DESIGN ADVISORY BOARD Tuesday, September 9, 2014 Conference Room 12, City Hall, Burlington, VT AGENDA

15-0055CA: 15 CONGER AVENUE (RL-W, Ward 5) David Maynard et al/Patrice Stratmann
Construct second story addition to existing garage structure and convert to single family dwelling. (Project Manager: Scott Gustin)

TO: Design Advisory Board
FROM: Scott Gustin 
DATE: September 9, 2014
RE: 15-0055CA, 15 Conger Avenue

Request: Construct second story addition to existing garage structure and convert to single family dwelling

RECORD OWNER: DAVID MAYNARD, et al.
EXISTING HEIGHT: 14'-4"
PROPOSED HEIGHT: 27'-4"

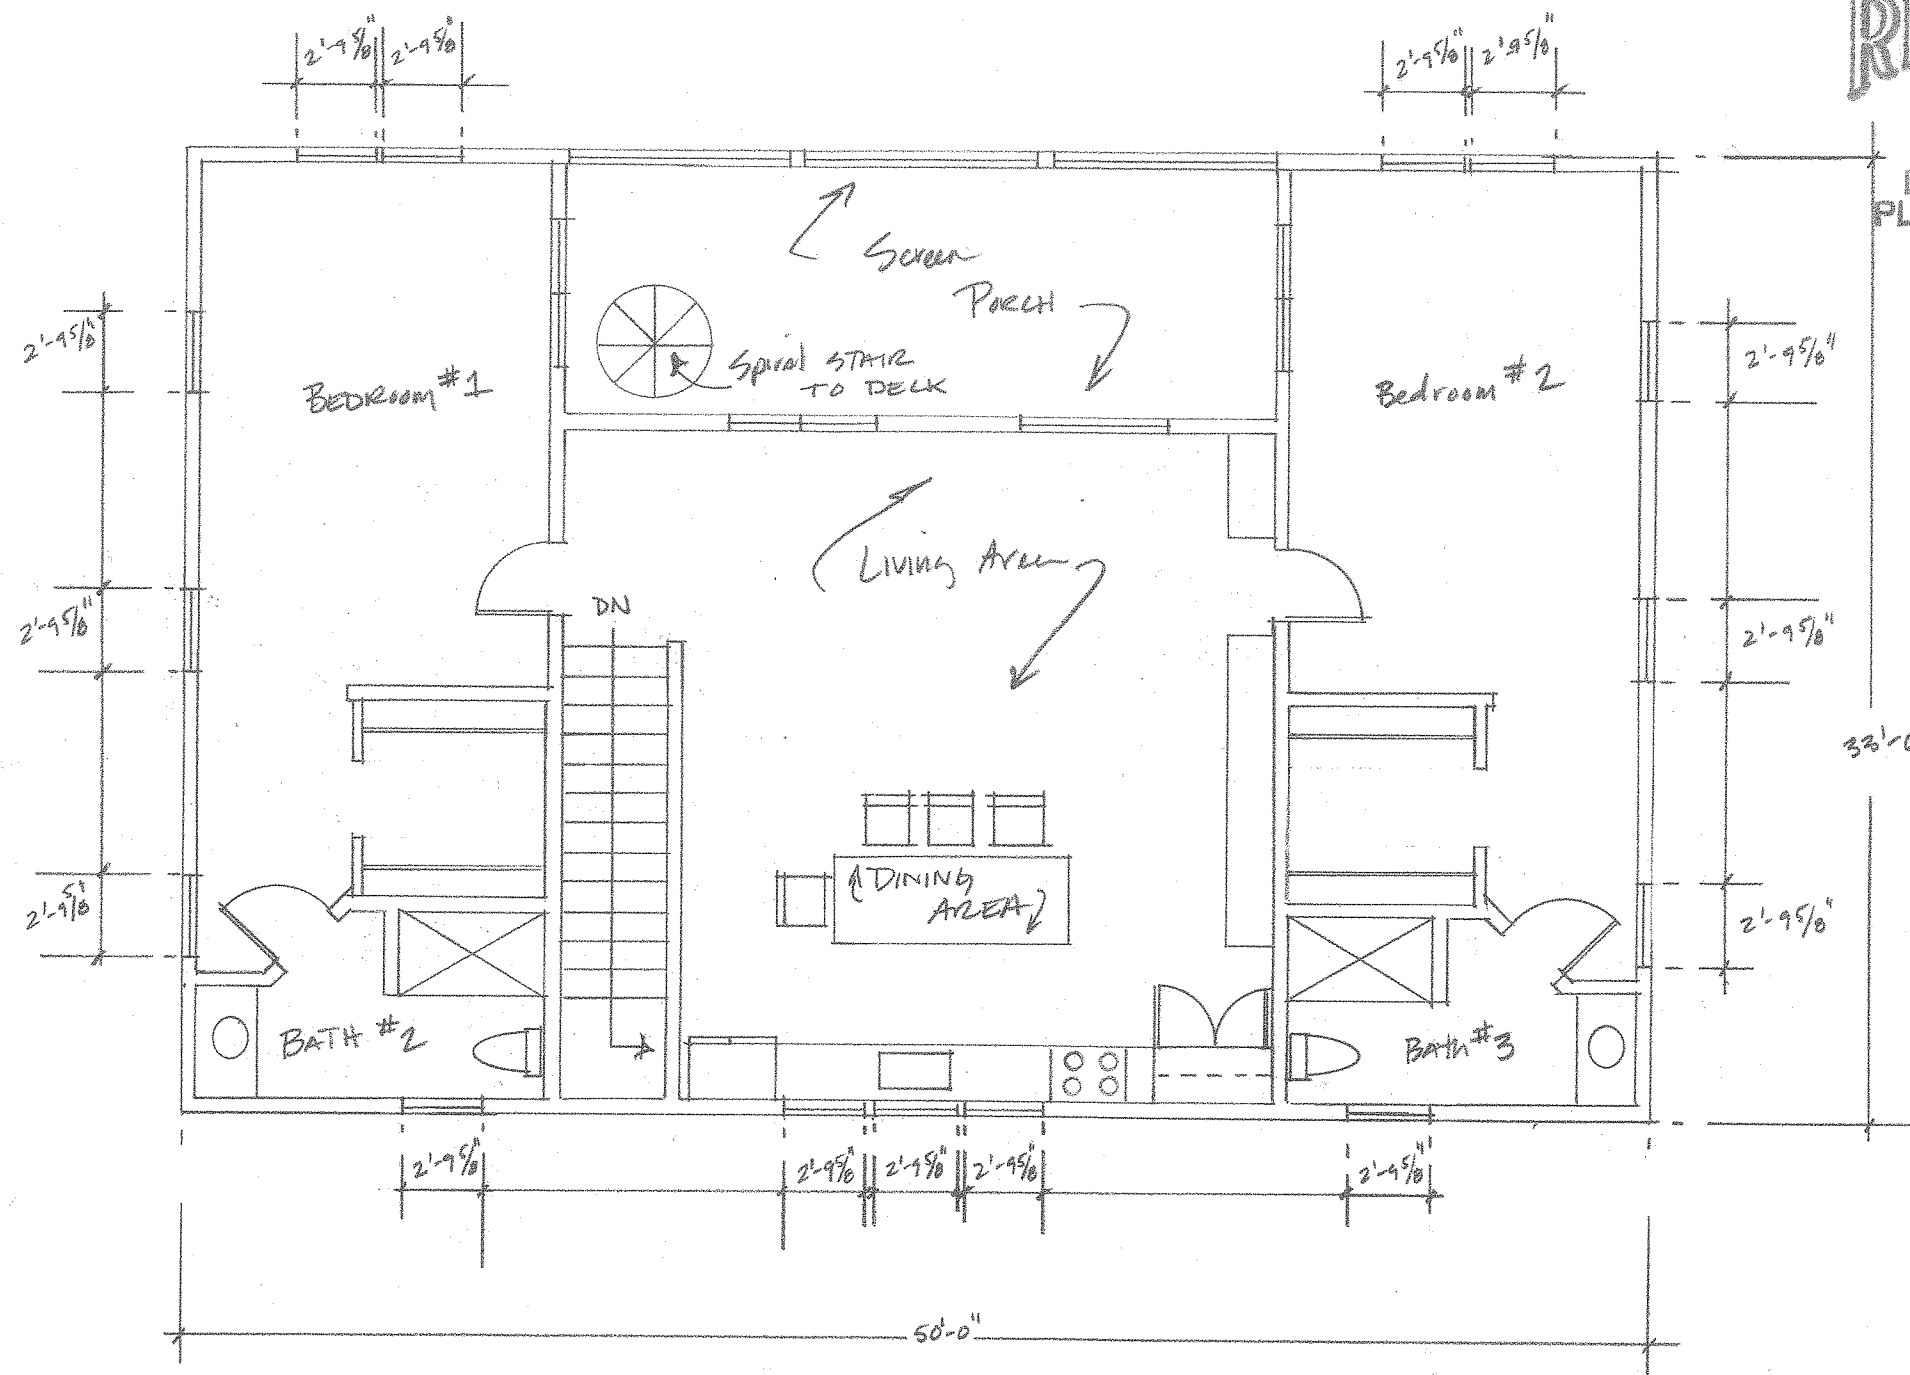
The garage presently contains four overhead doors facing Conger Avenue. Two of the four will be retained for access into the 2-bay garage. A single driveway will lead to these two garage doors. The driveway is 20' wide and exceeds the 18' maximum width. It must be narrowed accordingly (it may flare up to 20' by the garage entries). Driveway materials are undefined and must be noted. The driveway should be paved.

The revised plans contain minimal landscaping details and note only that a ginkgo tree will be planted in the front yard. The plans continue to refer to a "courtyard" in front. What the courtyard consists of is unclear. Grassy or garden area would be acceptable. Lot coverage constraints would prohibit any sort of hardscape material. Details as to what the courtyard will be are needed.

The previously proposed 7' tall masonry "fence" has been deleted in favor of a 3' tall wooden fence. Note that the plans refer to a wooden or masonry fence. Consistency with the application narrative requires that the plans be revised to indicate just a wooden fence. The newly proposed fence is much more appropriate to this neighborhood context and complies with the clear sight triangle for the driveway/street intersection.

Revised project plans now depict outdoor lighting fixture locations. They will illuminate the pedestrian and garage entries into the building. Note that locations noted on the site plans are

inconsistent with locations noted on the building elevation drawings. This inconsistency must be fixed. Fixture cut sheets have not yet been provided and need to be.

1. Building location and orientation. Original 7 foot tall masonry wall has been deleted and, instead, a 36 inch wooden fence is proposed to enclose the front yard area. The front door to the building is now visible from the street and will be accessible directly via a sidewalk from the city sidewalk.
2. Vehicular access. Proposal is to delete two of the existing for driveway areas located in front of the garage building. Two of the "bays" will be converted to a new front yard area (see above). The other two bays will be maintained as driveways to access the remaining garage area.

3. Pedestrian access. A sidewalk is now shown connecting the public sidewalk to the building's primary entrance.
4. Landscaping and fences. A 3 foot tall fence is now shown in lieu of the original proposed masonry wall.

The driveway should not be more than 18' wide.

The fence should be 3' tall and wooden.

SOUTH ELEV.

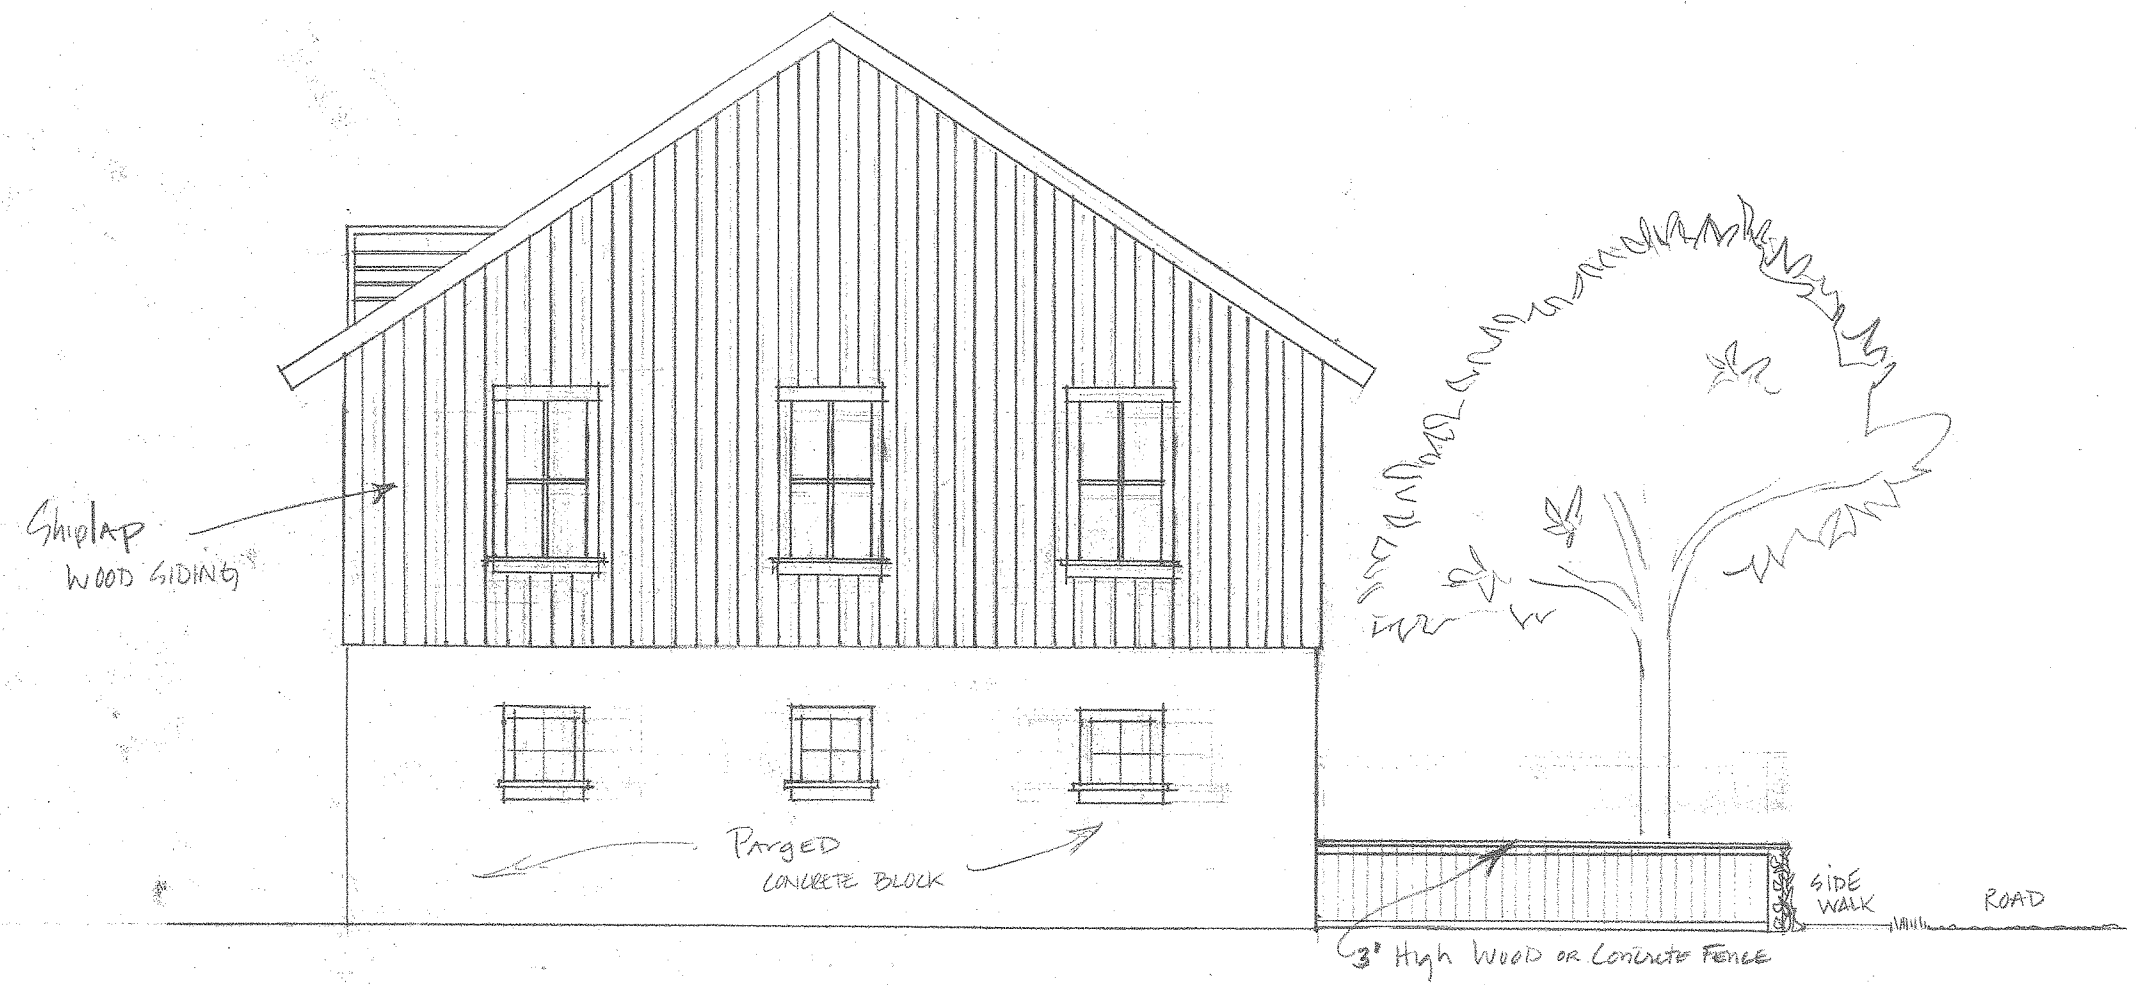
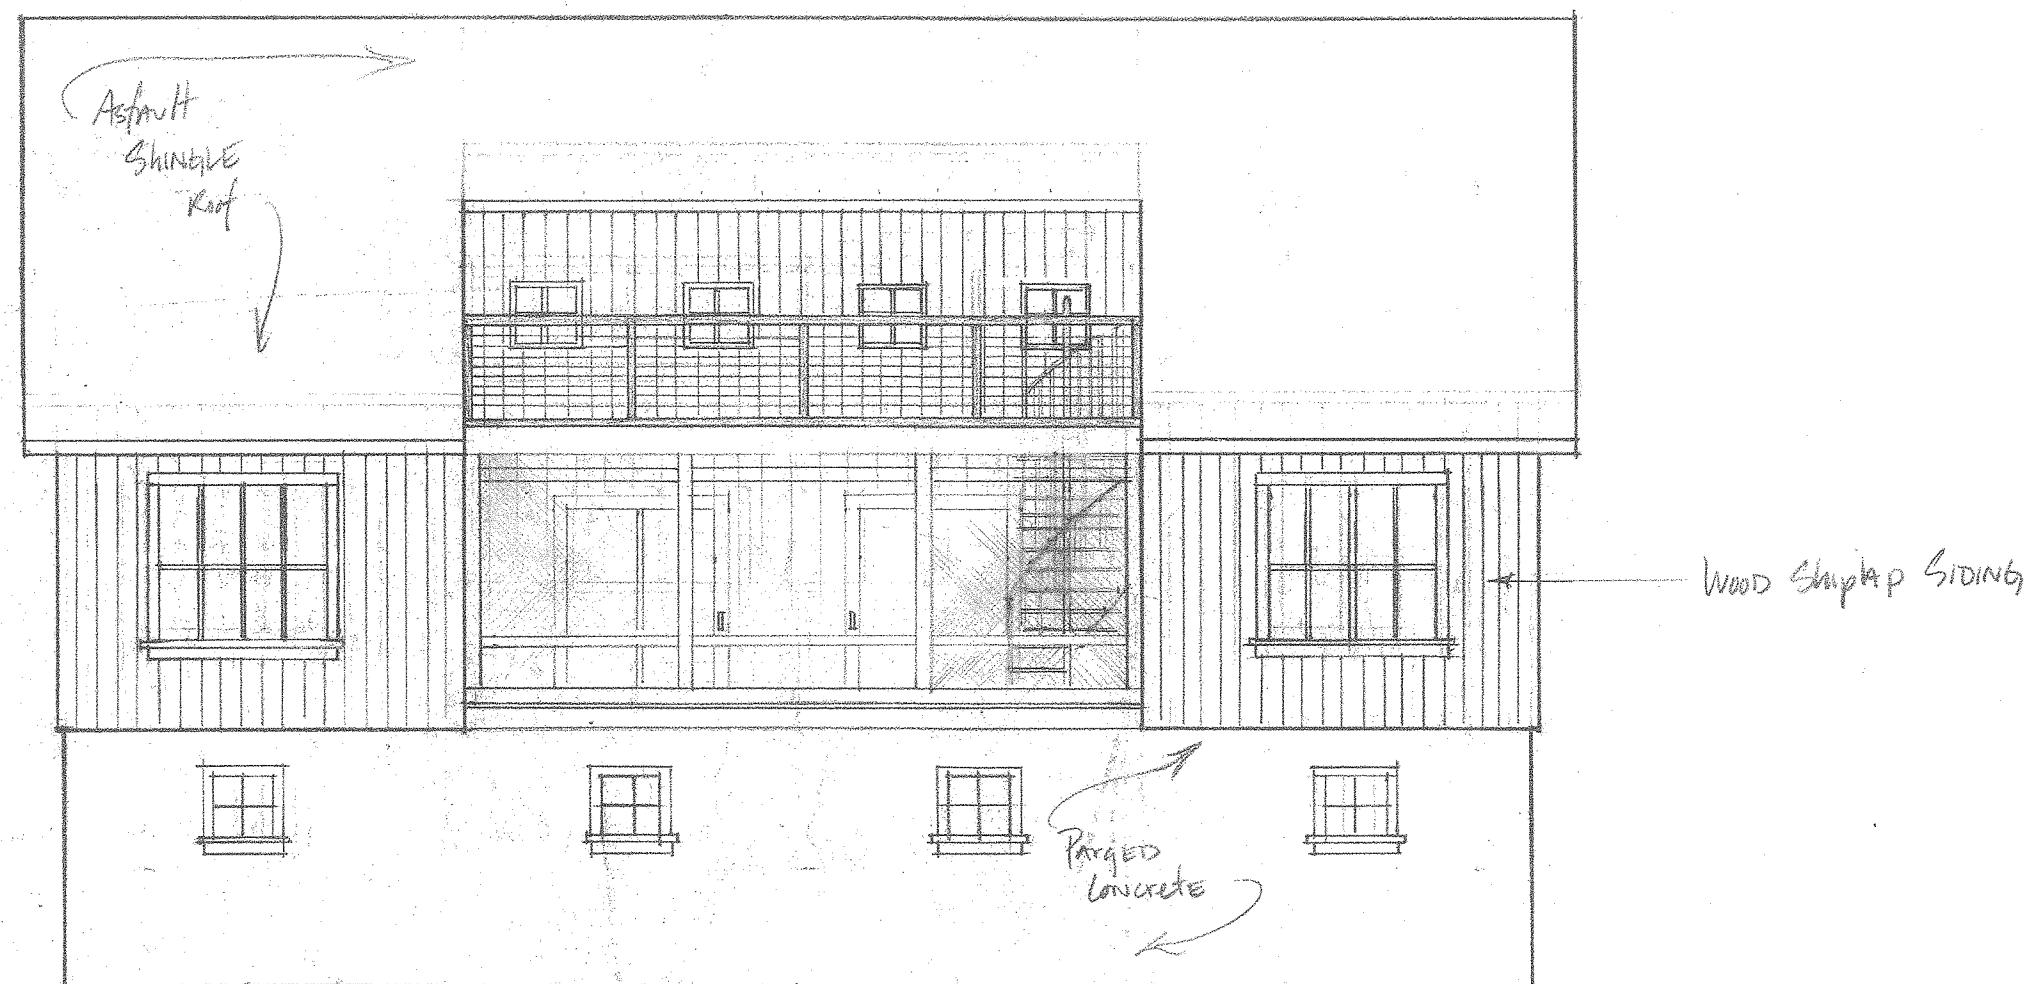
Any new utility lines must be buried. The site plan depicts a utility meter on the south side of the building. The south building elevation does not depict the utility meter. The utility meter must be depicted and screened. See also Sec. 6.3.2 (h) below.

As noted above, utility meters will be located on the side of the building. They must be noted on the building elevation drawing and screened. No exterior mechanical equipment is included in the project plans. If any is proposed, it must be depicted and screened. Trash should be stored inside the garage until curb side pick-up days.

5. Outdoor lighting. Fixture locations are now shown on the building elevations and plans.
6. Integrate infrastructure into the design. All utility supply will be made underground. The electric utility meters located on the south side of the building will be screened from the road/sidewalk with a cedar shrub.
7. Building openings. Window drawings are now provided in more detail.
8. Quality of materials. Material types and locations are now specified on the plans.
9. Reduce energy utilization. All construction will meet current energy efficiency requirements and regulations. For example, we propose to use insulated concrete filled foam blocks ("ICFs") to construct the first floor structure. This technique will allow enhanced energy efficiency in addition to providing necessary fire protection.

Utility meters should be screened.
